MYERS CHUCK HARBOR FACILITIES PROJECT NO. K-31521

AS BUILT

START : MAY 31, 1985
STOP : JULY 9, 1985
CONTRACTOR : DAWSON CONSTRUCTION CO.
PROJECT ENGINEER : MARK HALVORSEN
DATE : JULY 19, 1985

STAMP		DO NOT SCALE THIS DRAWING - USE DIMENSIONS	
		STATE OF ALASKA	
		DEPARTMENT OF TRANSPORTATION AND PUBLIC FACILITIES	
		Myers Chuck	Alaska
PROJECT LAYOUT			
DESIGNED <u>RPB</u>	CHECKED <u>JDB</u>	DRAWN <u>TS</u>	DATE <u>7/84</u>
PROJECT NUMBER <u>K-31521</u>	SHEET <u>2</u> OF <u>7</u>

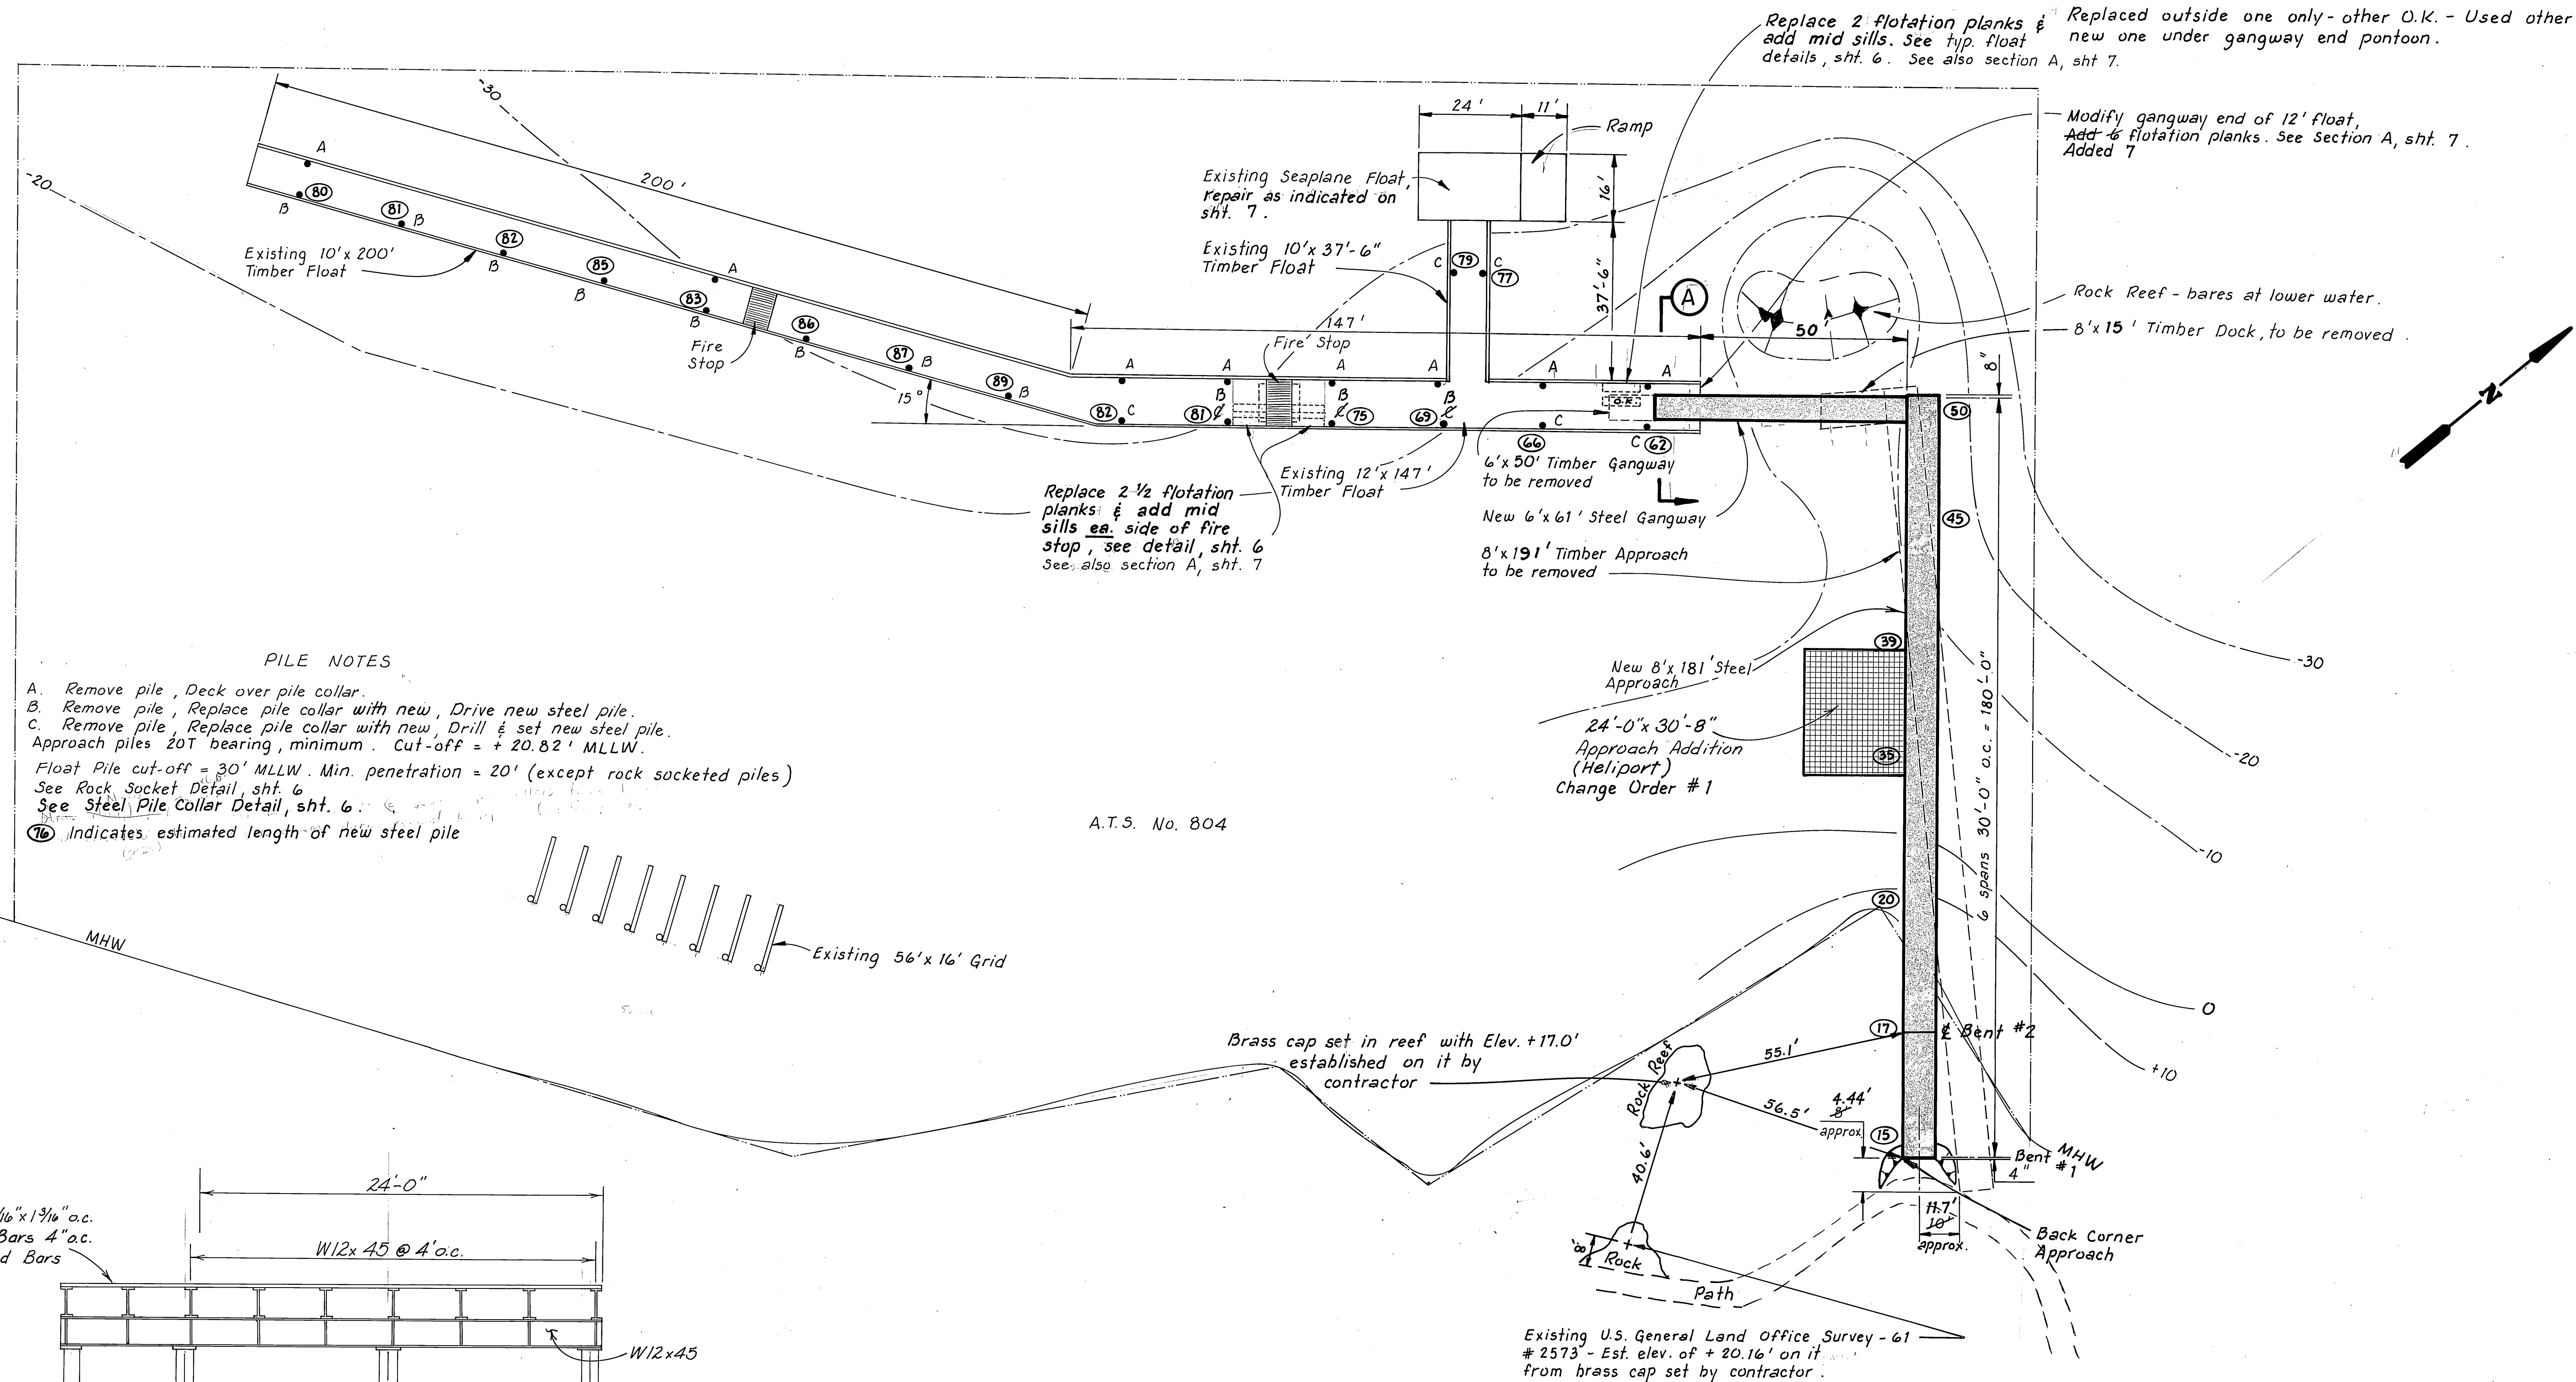
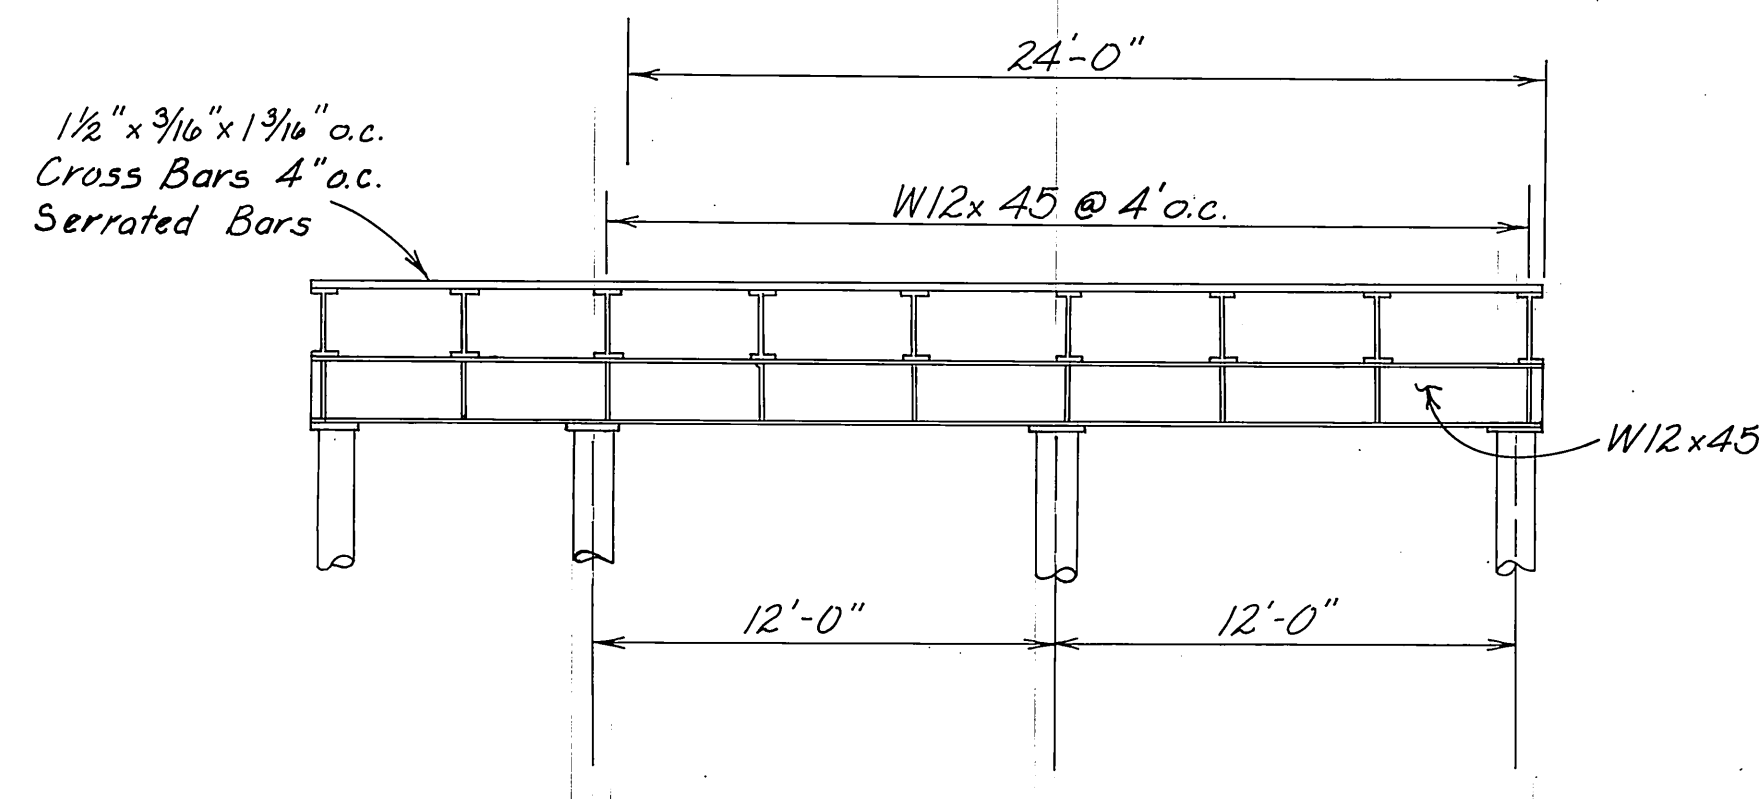
WIDENED HELIPORT Change Order #1
CAPS DETAIL
1" = 5'

M.H. 7/9/85

STEEL PILE SOCKET DETAIL N.T.S.

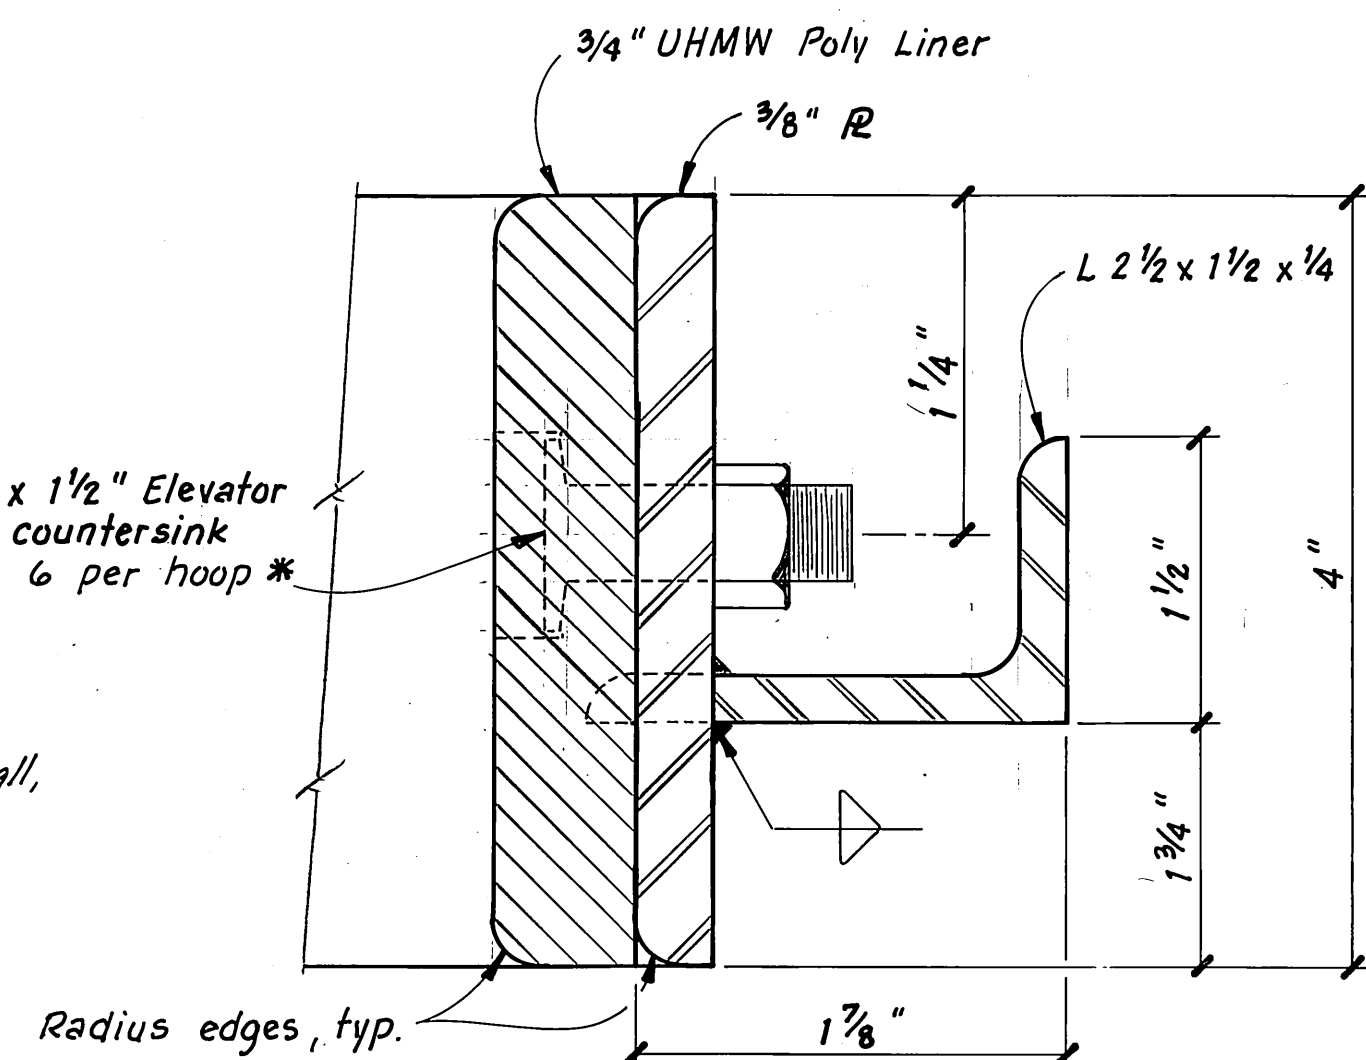
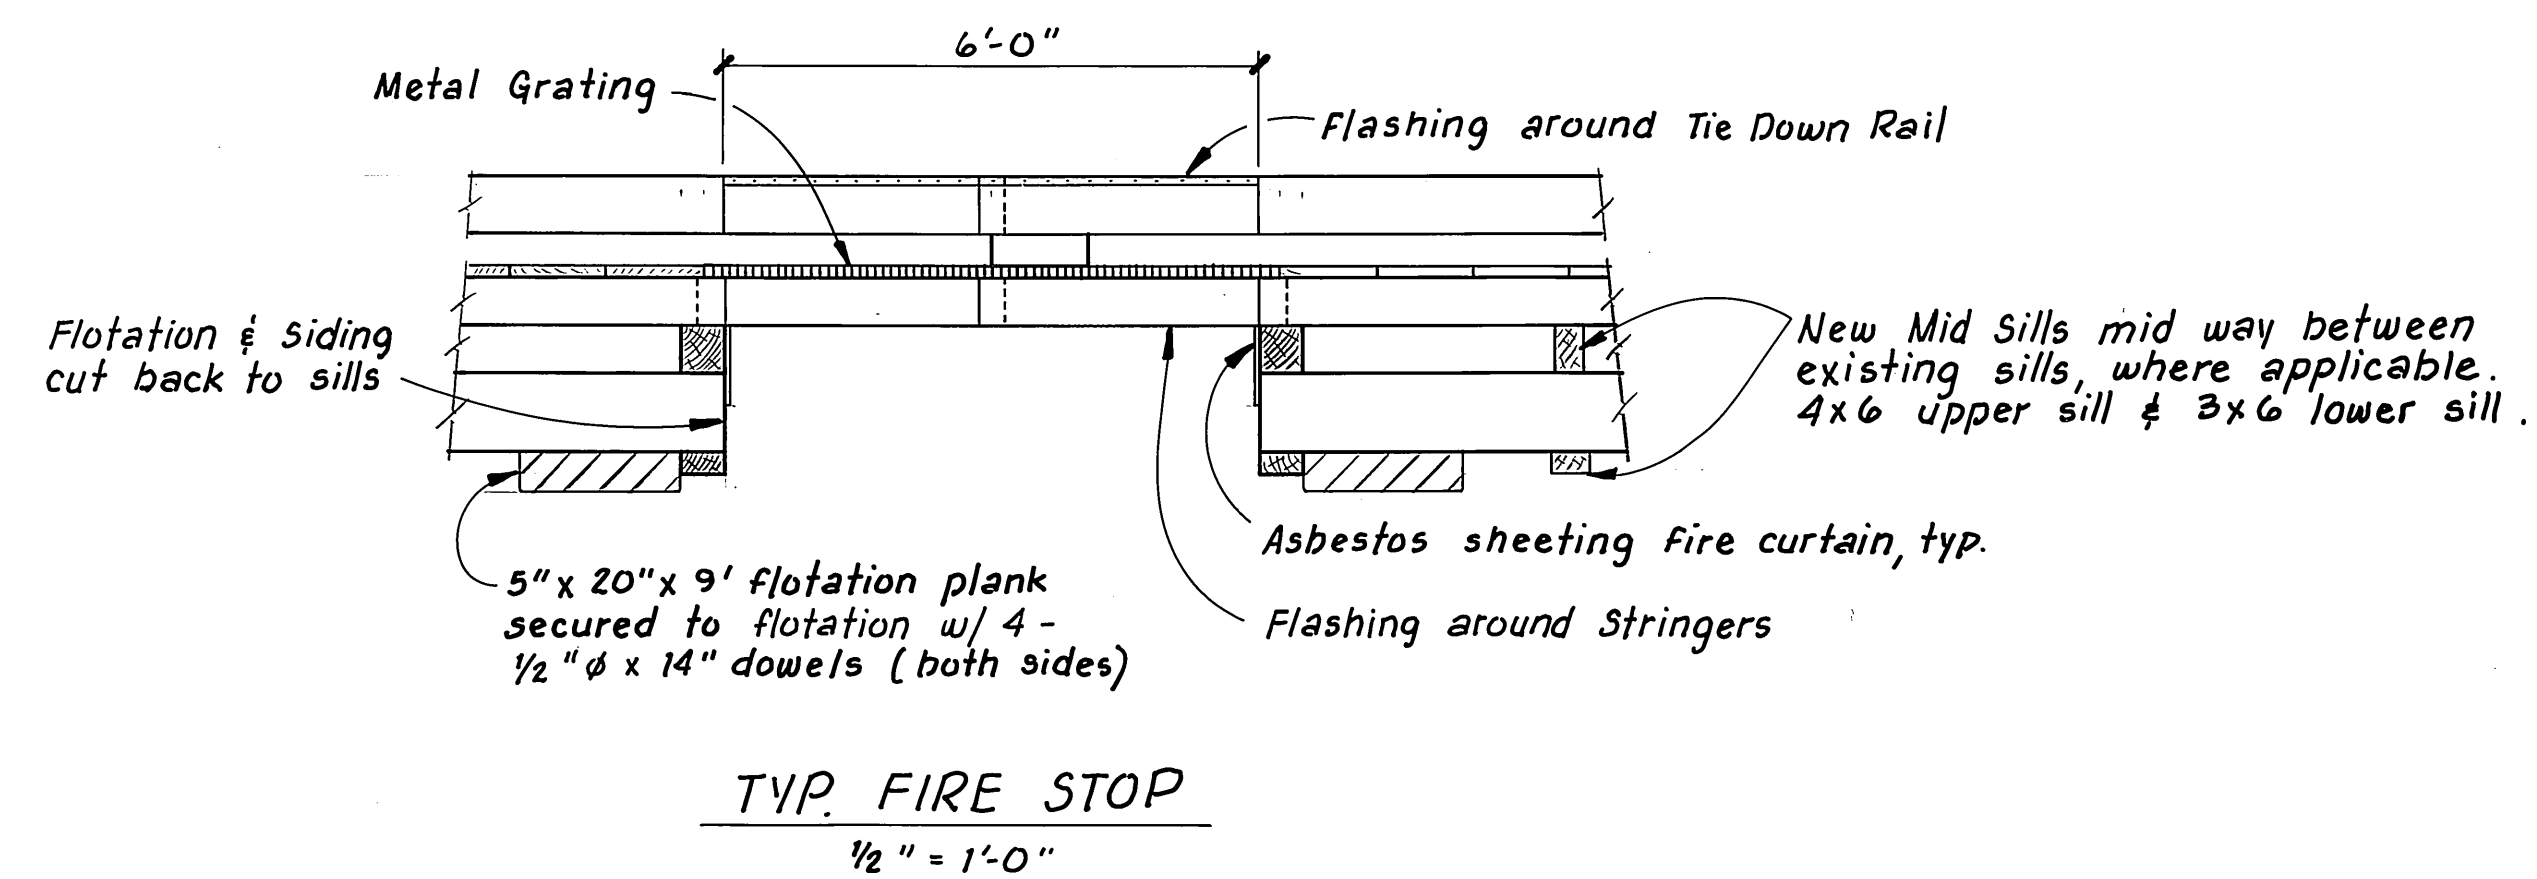
and no payment for socketing will be made

Drilled 15" ϕ hole, drove pile to ref. in it & backfilled remainder.
